3 Volt Intel[®] Advanced+ Boot Block Flash Memory

28F800C3, 28F160C3, 28F320C3, 28F640C3

Specification Update

November 2002

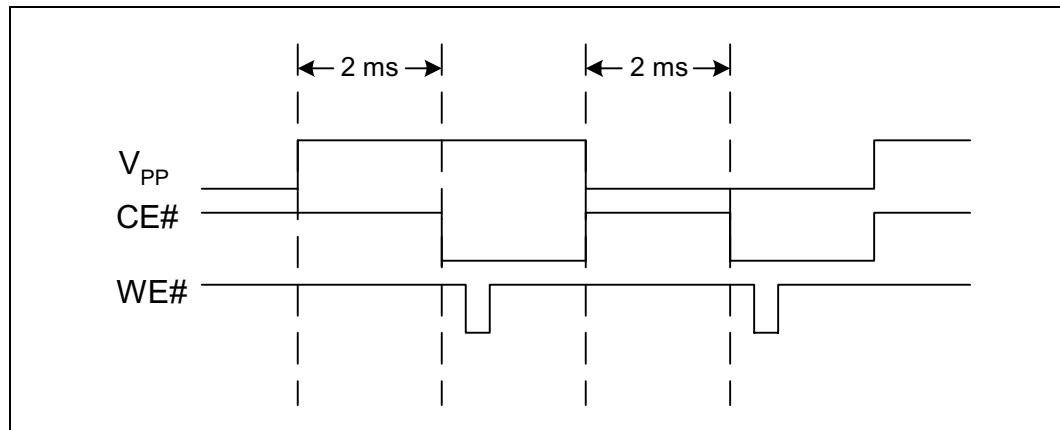
Problem: The 0.18 μ m 28F320C3xC devices can unintentionally reset under certain conditions where V_{pp} toggles.

Implication: When the reset occurs, any command being executed is interrupted and the flash switches to read array mode.

- 1) Tie V_{PP} to V_{CC} ;
- 2) If the third and fourth digits on the top side FPO mark (third line) is equal or greater than “23”, then V_{CC} may be set from 2.7v to 3.3v. V_{CC} must not exceed 3.3v
- 3) Set V_{pp} to a static high or static low level as shown here; and

4) Wait 2 ms after a V_{PP} transition to access the flash device, as shown here.

Figure 1. Workaround Placement

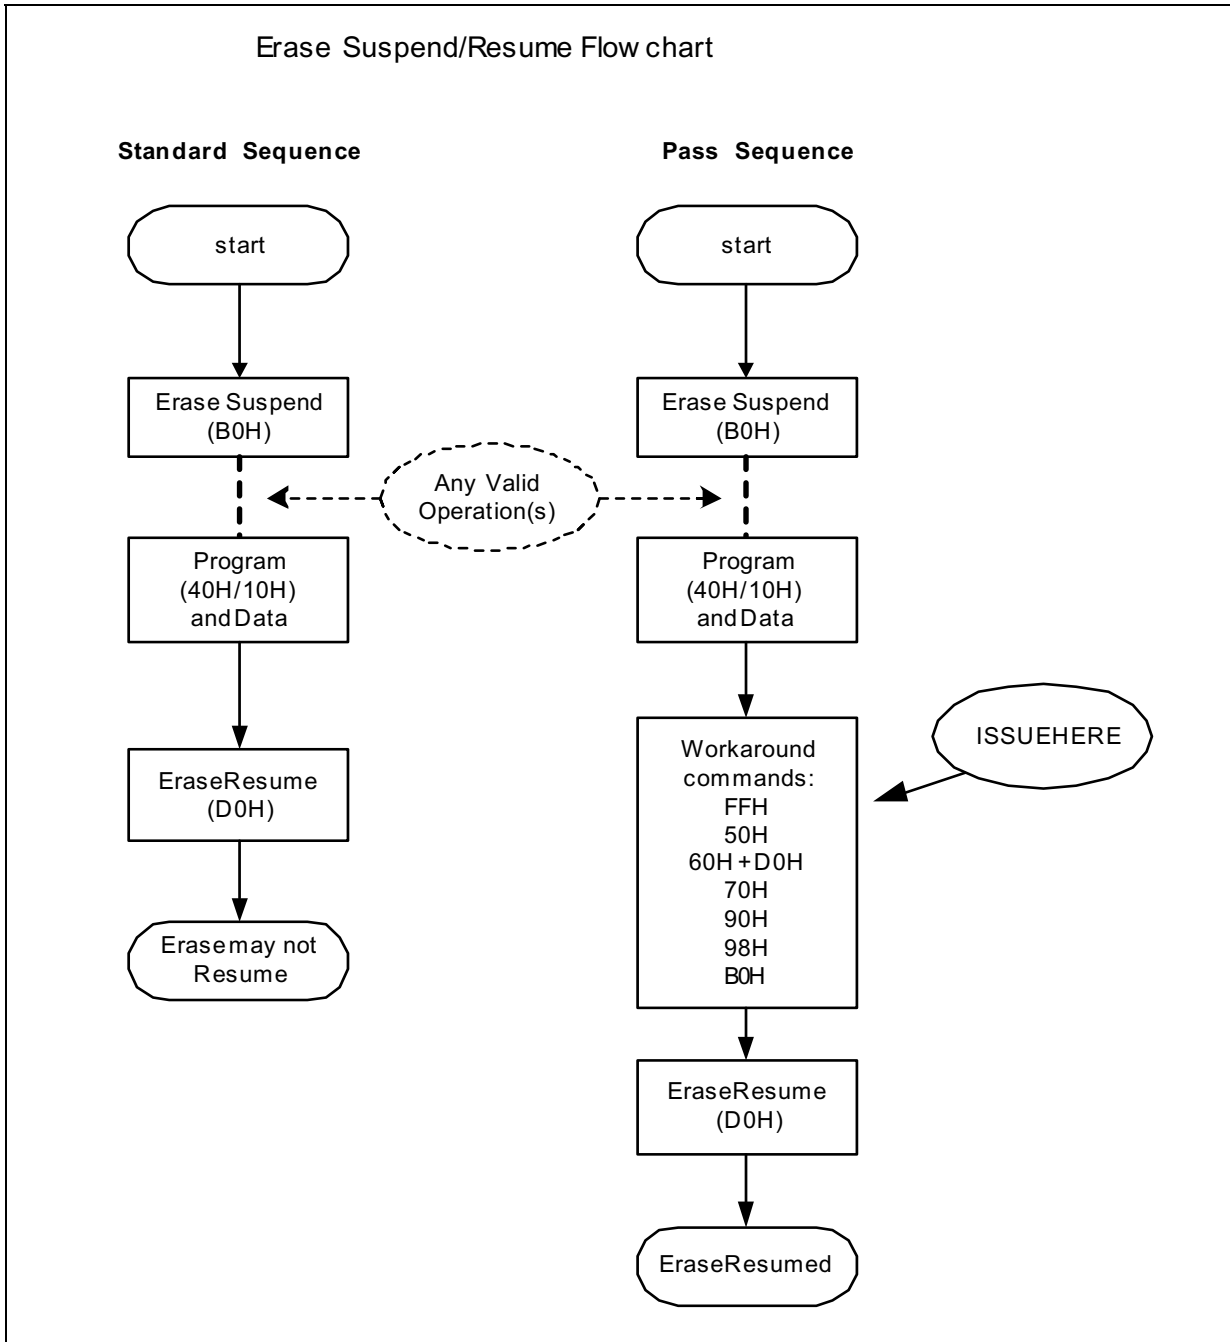
Problem: On the 0.18µm 28F160C3xC devices, a design anomaly was discovered. During an Erase-Suspend operation, if the Program (40H/10H) sequence is executed, under limited conditions the proceeding Erase Resume command (D0H) may not actually resume the device. No customers have reported failures in product applications. Customers who use any version of FDI (Intel Flash Data Integrator) software will not see this issue. If the Read Array command is issued prior to the Erase Resume command, users will not see the issue (typical in XIP applications).

Implication: The Resume Command (D0H) may be ignored by the device and will not correctly resume. The device will appear to remain in suspend (via status register). After a reset of the flash device the status register will clear. This failure has been recreated in a lab environment only.

1. If FDI (Intel Flash Data Integrator) software is used, users will not see the issue.
2. During an Erase-Suspend (B0H), user must issue any of the following commands after issuing the Program (40H/10H) and data sequence but before issuing the Erase-Resume (D0H) command.

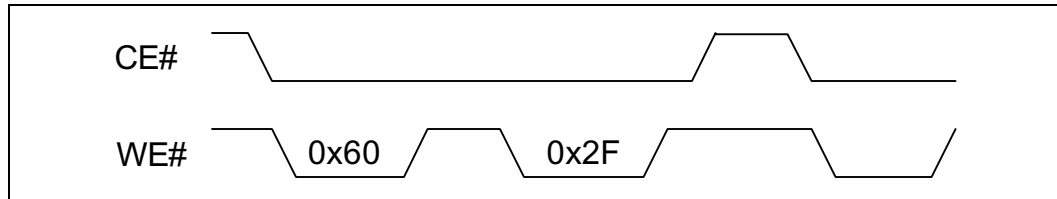
Problem: On the 16Mb and 64Mb 0.18µm devices, if CE# is deasserted after any block lock operation and before the next write sequence, the part may perform the same operation on additional blocks. (See waveform below.)

Implication: When CE# is deasserted after performing a block lock operation to a specific block and prior to the next write sequence, other blocks may perform the same operation.

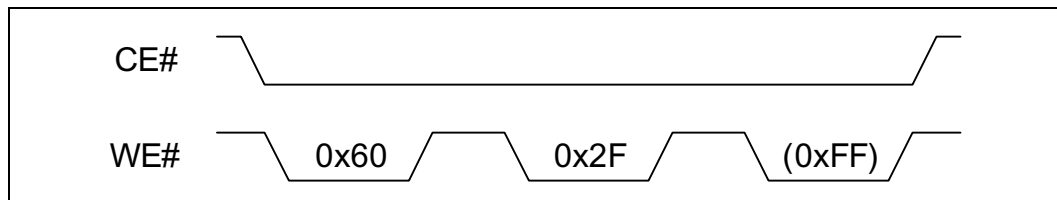
Immediately after performing a block lock, unlock, or lock-down operation, perform a valid write sequence before chip enable (CE#) is deasserted.

- 1) Assert CE# and toggle WE# to write the block lock setup command (0x60).
- 2) Toggle WE# a second time to write the confirm command (lock = 0x01; unlock = 0xD0; lock-down = 0x2F).
- 3) Toggle WE# a third time (ex: 0xFF- Read Array) before CE# is deasserted. (See waveform below.) Any other valid write sequence will also work (i.e., 0x90 - Read Configuration, 0x40 - Program, 0x20 - Erase).
